### SANTA ANA RIVER TRUNK SEWER REPLACEMENT PROJECT - PHASE II

# AS-BUILT

## JANUARY 3, 2017

**SANTA ANA RIVER TRUNK SEWER REPLACEMENT - PHASE II**  
**COVER SHEET**

**EAST SIPHON AREA TRUNK SEWER CONNECTION - PLAN VIEW**  
SCALE: 1"=10'

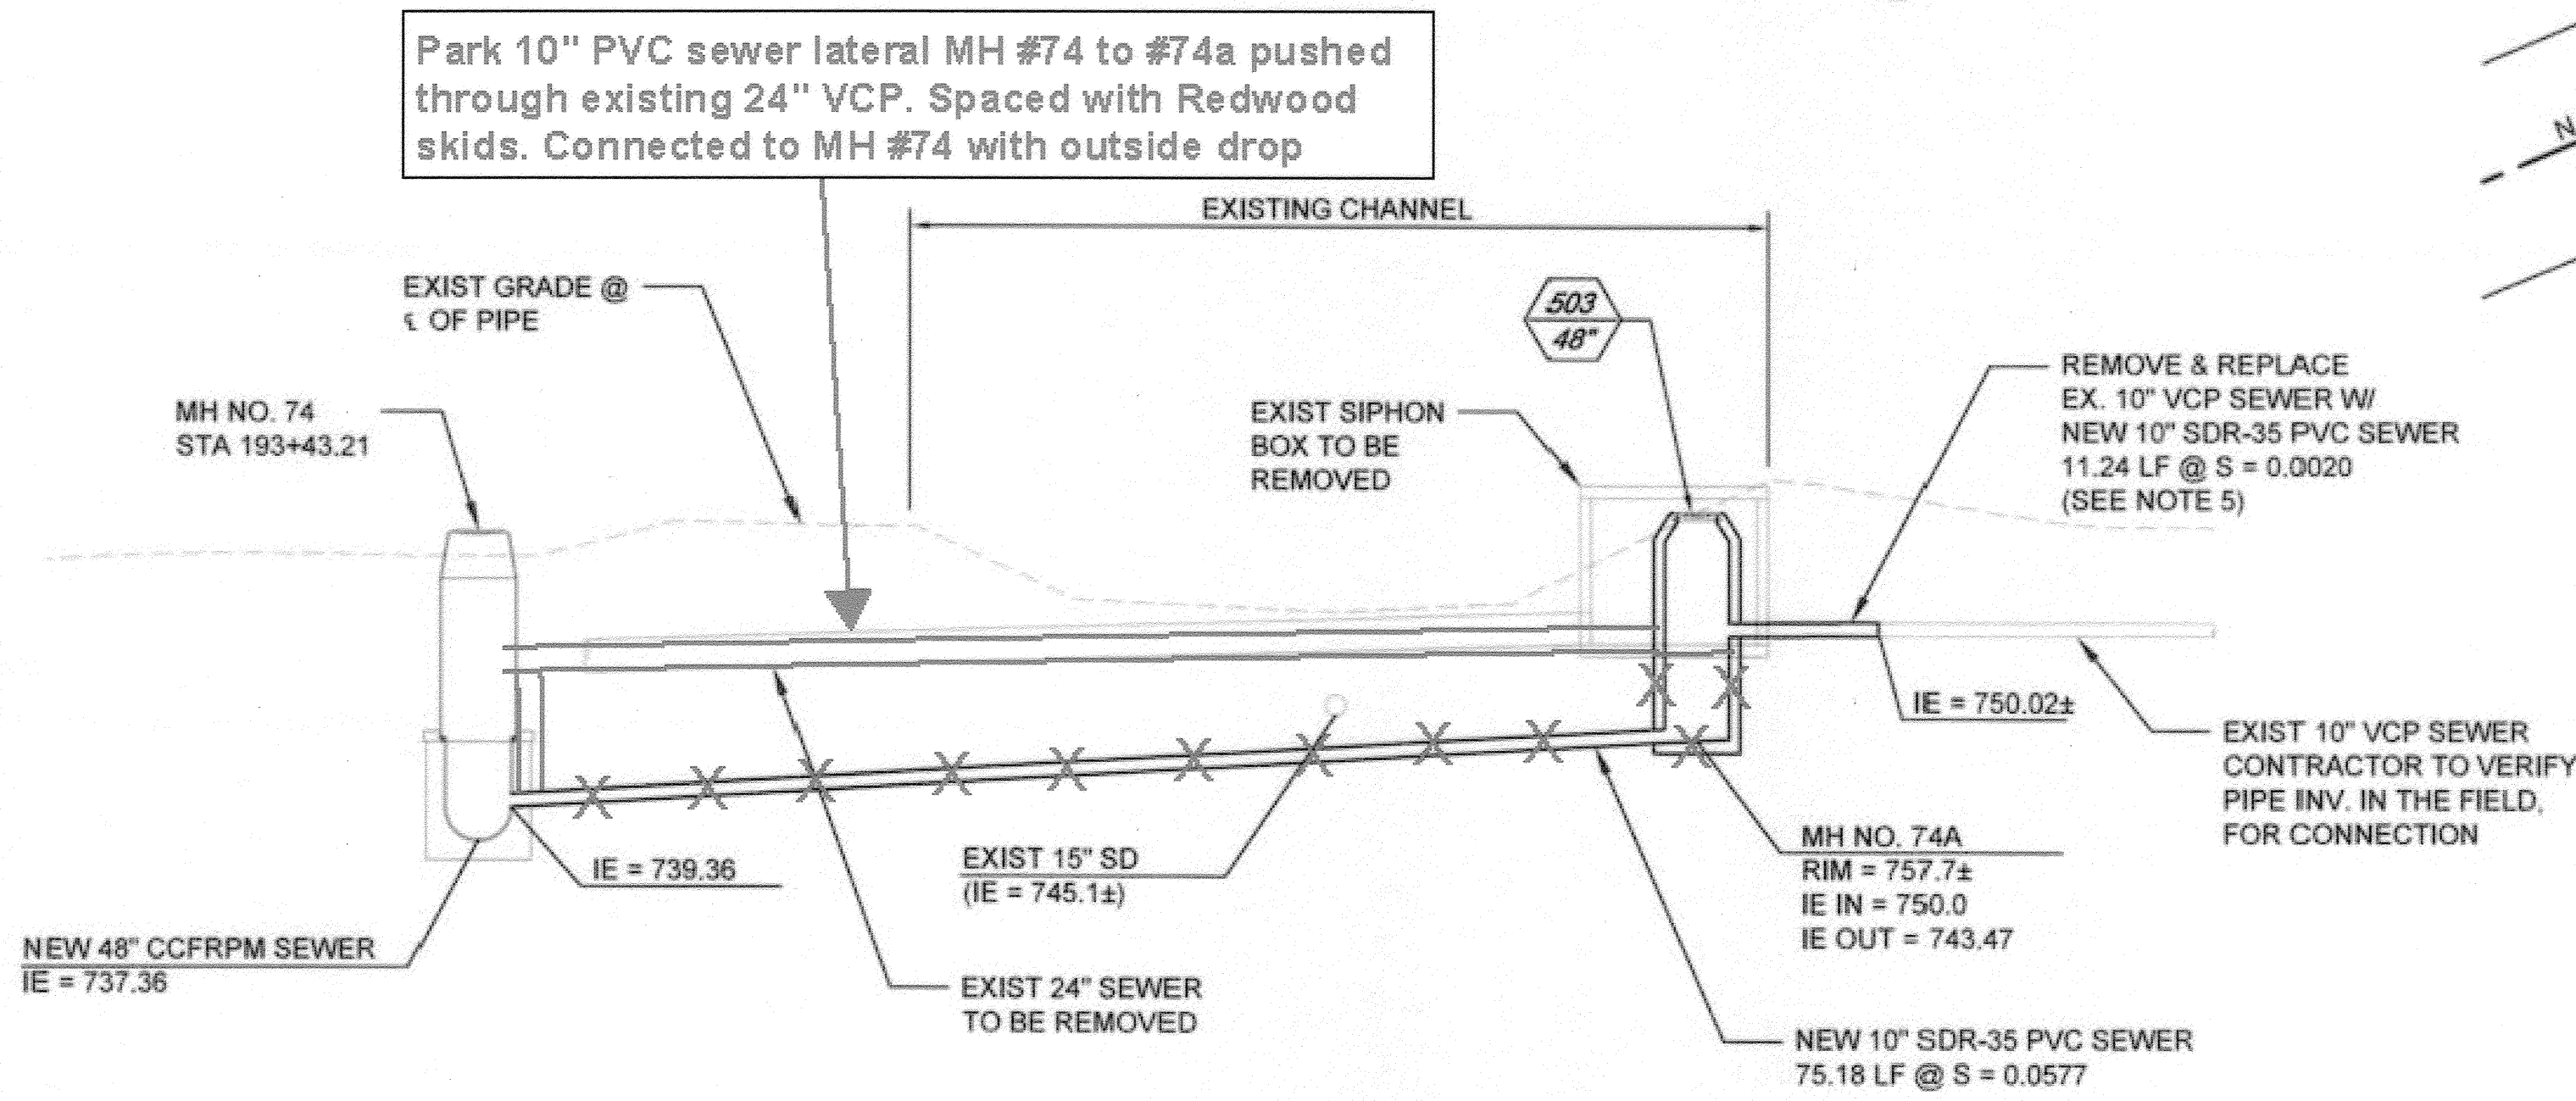
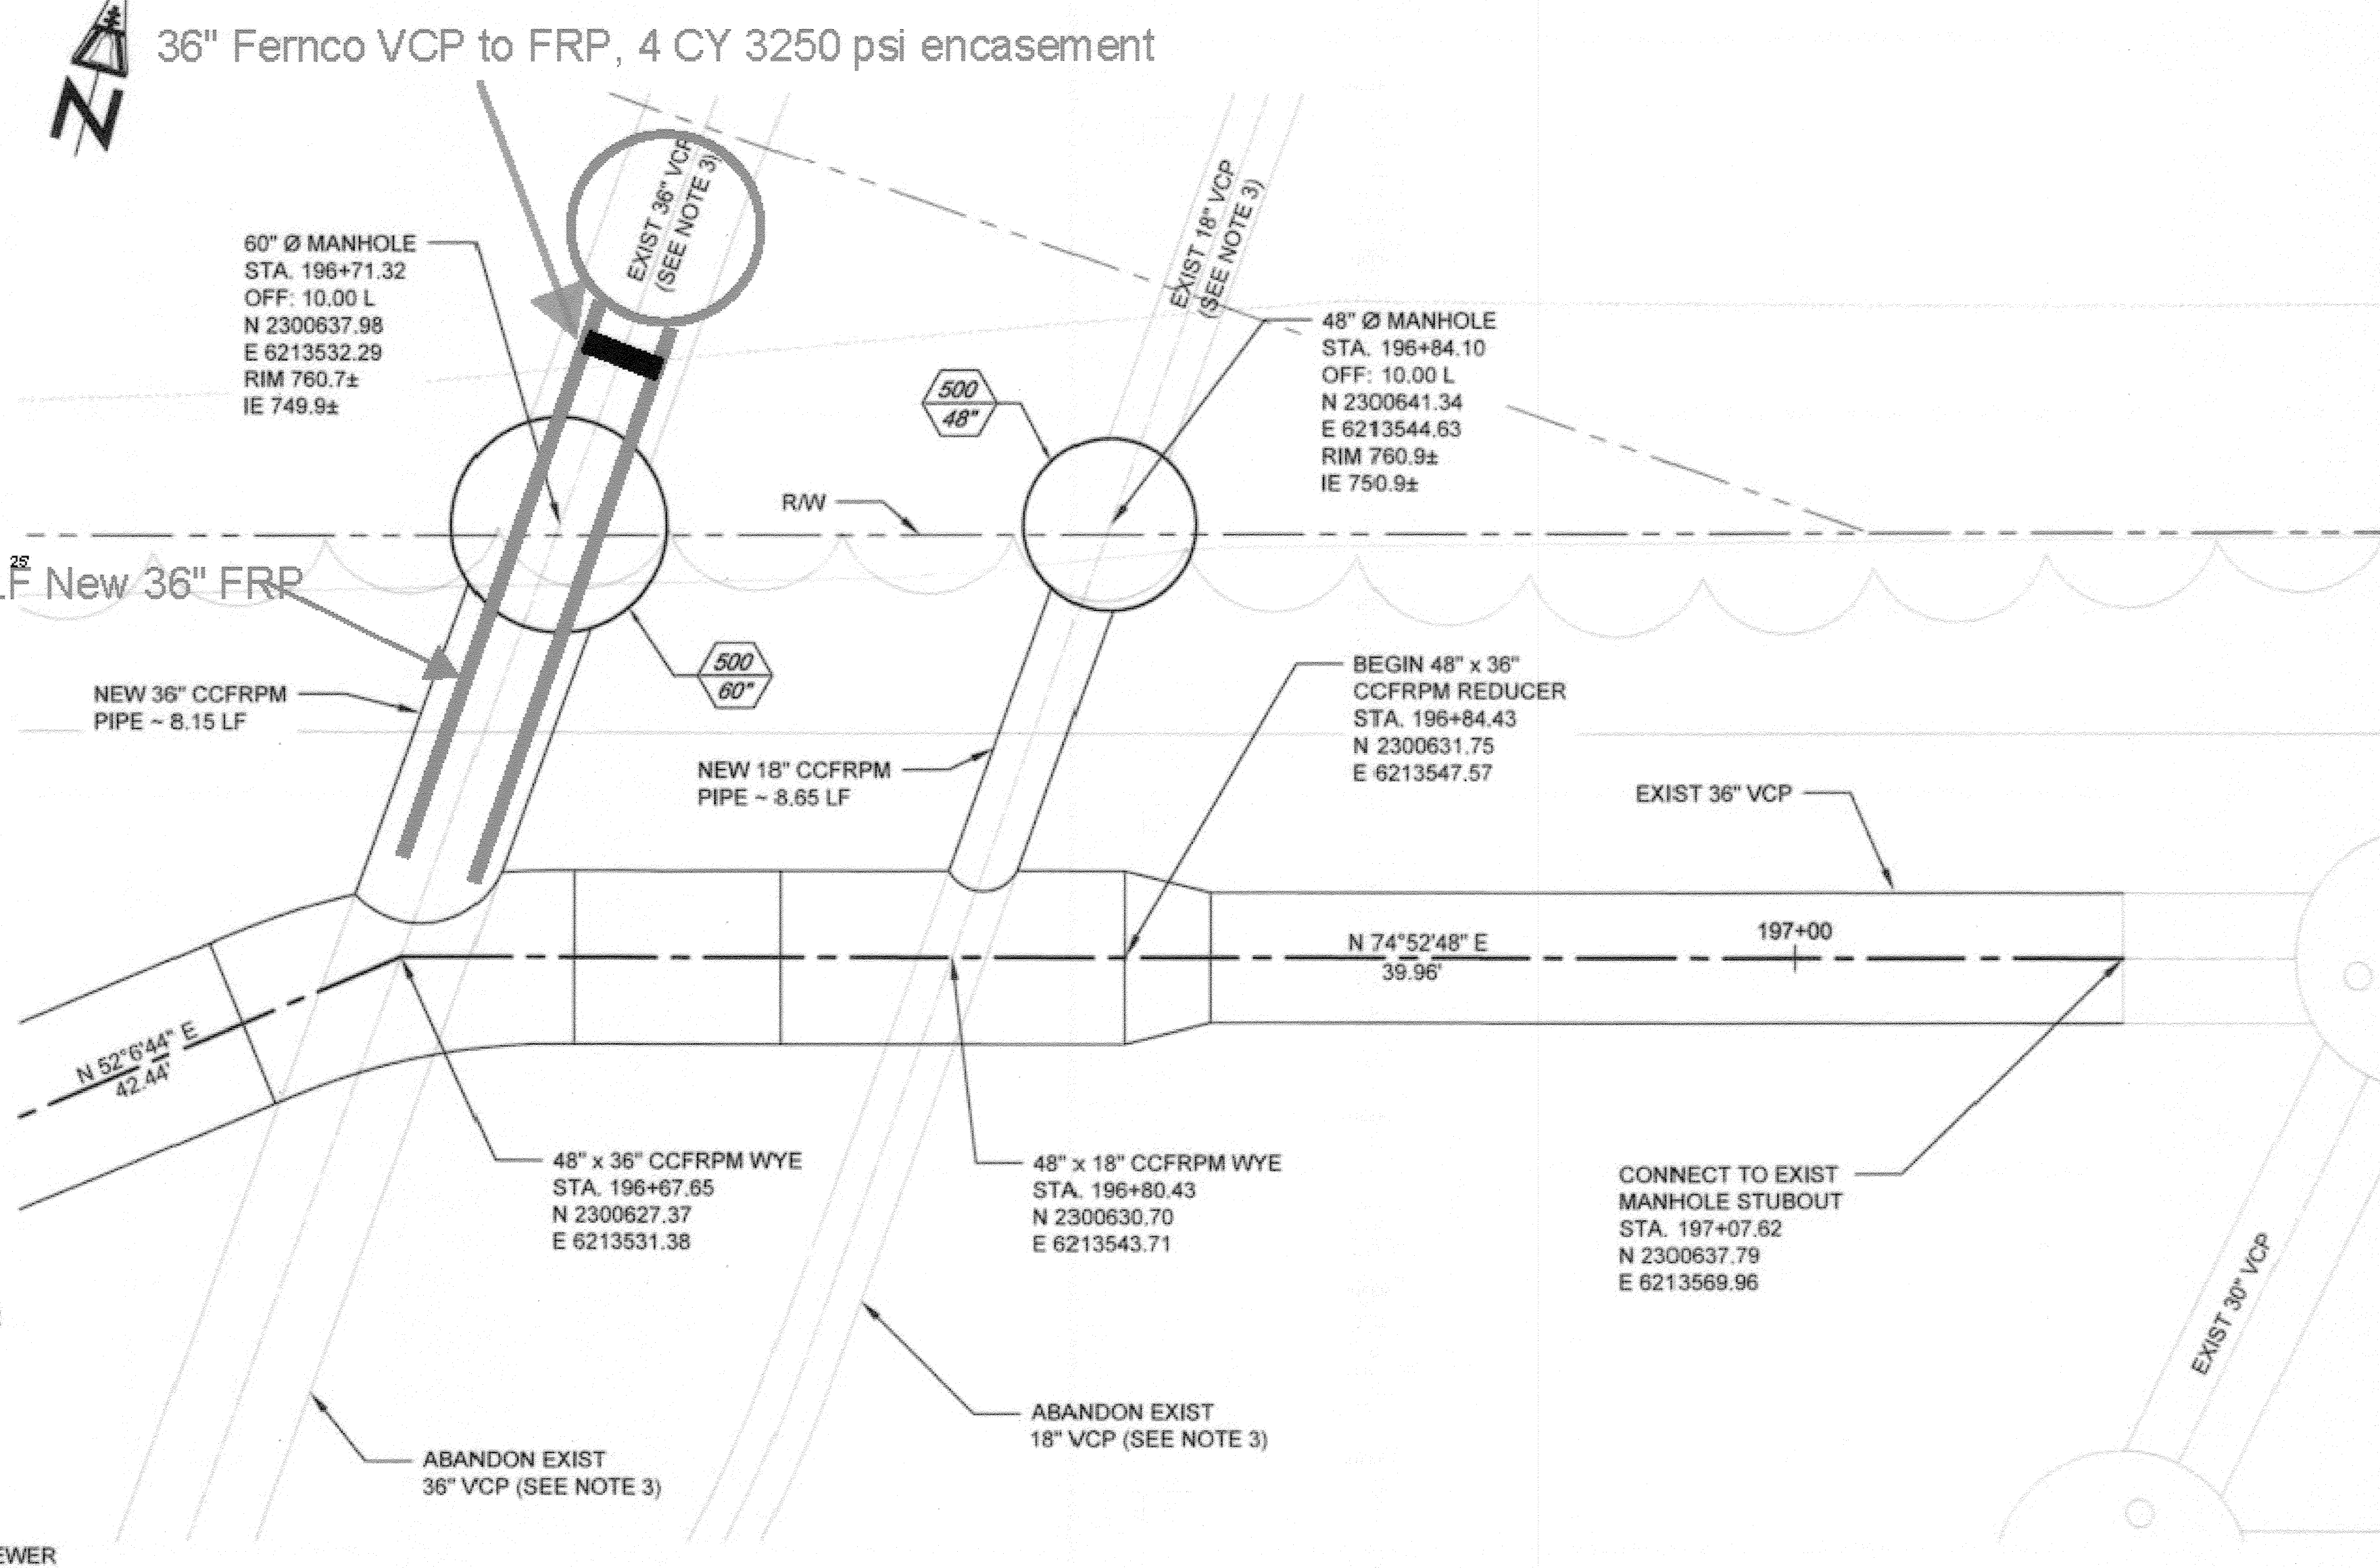
Revised plan as shown  
3/16/15
